Revisions for Wavelength Plan A

Yong Guo
Xingang Huang
Jun Shan Wey

Table 1. Upstream wavelength shifted by 50GHz

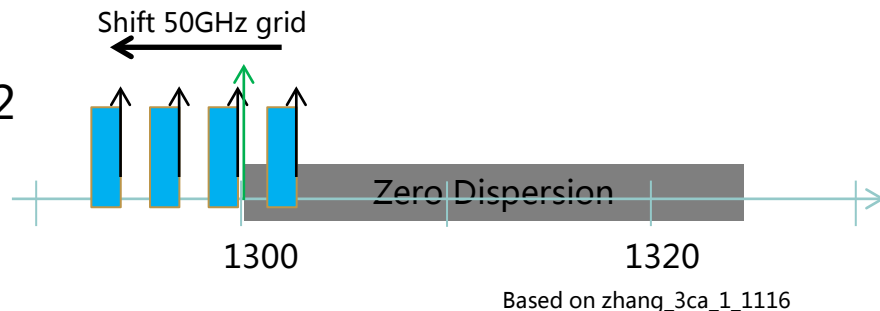
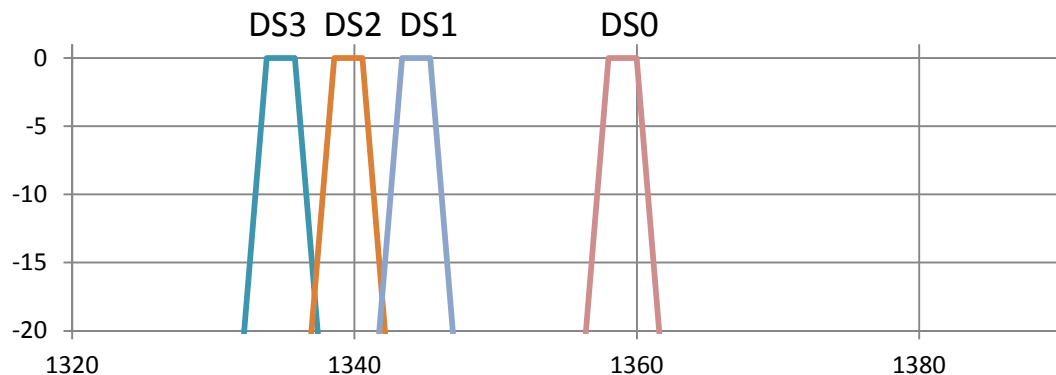
Revision to mitigate the worst case FWM penalty

In zhang_3ca_1_1116, the upper edge of US2 is shown to be ~12GHz (0.07nm) from the lower edge of the ZD zone (i.e., 1300nm). In the worst case, where all four upstream wavelengths are drifted towards longer wavelength, a 1.4dB FWM penalty could be observed for US2 channel.

Proposal:

- Shift all the upstream wavelengths to the shorter wavelength direction by at least one 50GHz wavelength grid.

Guard band between 10G-EPON and NG-EPON US

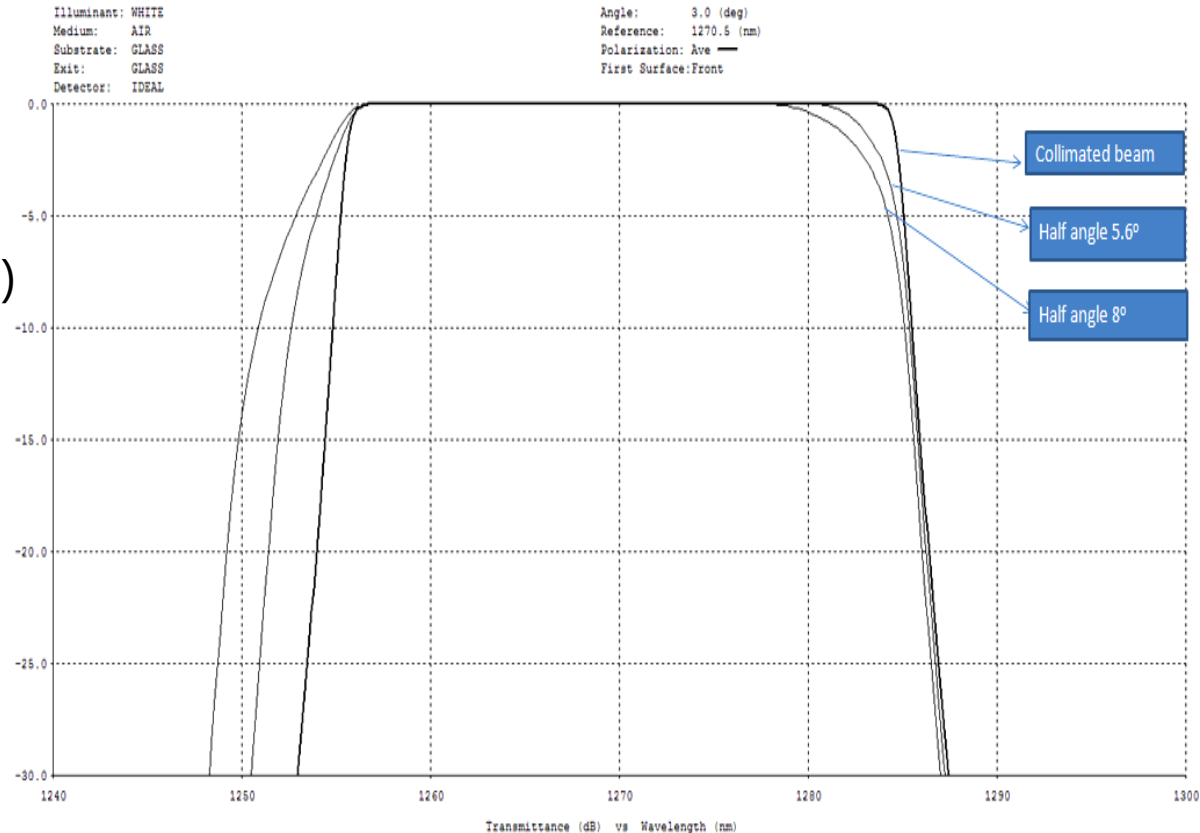
Based on simulations from filter vendors (only shows data from 1280nm-1290nm)

- Even 10nm is not enough for 45 degree TFF filter
- By using filters with small angles, guard band can be reduced to less than 10nm

Proposed revision of wavelength plan A

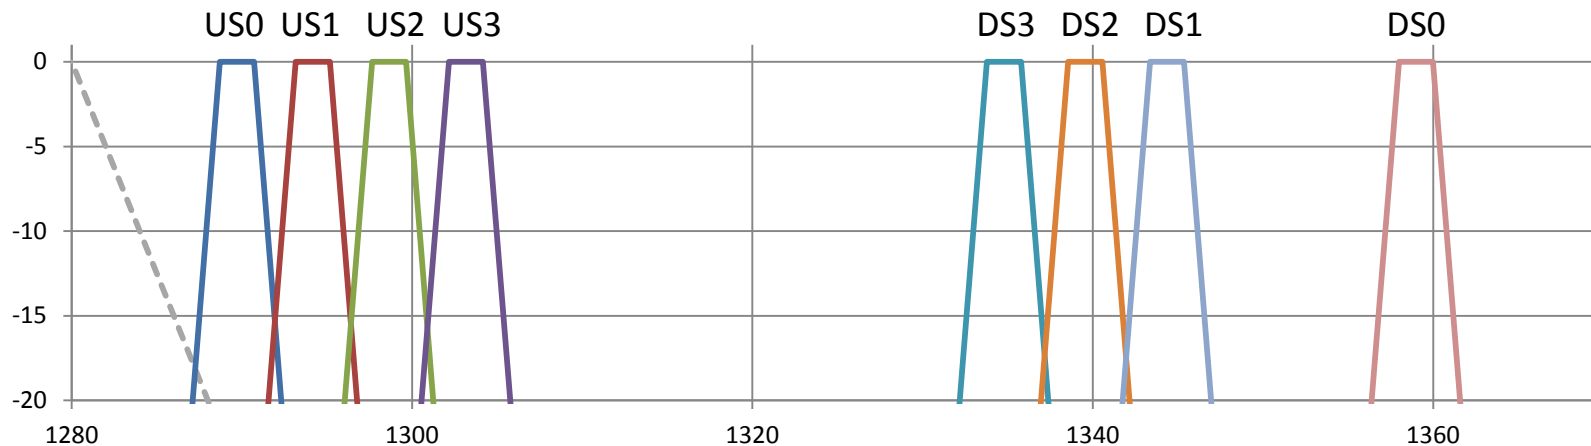
Proposed revisions of Plan A to address concerns from the last meeting:

- $\pm 1\text{nm}$ pass band and 800GHz channel spacing for upstream wavelength are kept
- All upstream wavelengths are shifted to the shorter wavelength direction by 50GHz
- The order of downstream channels are changed to DS3, DS2, DS1, DS0, where DS0 is moved to the longest wavelength side
- Guard band between 10G-EPON US and 25G US0 can be less than 10nm if filters with smaller angles are used
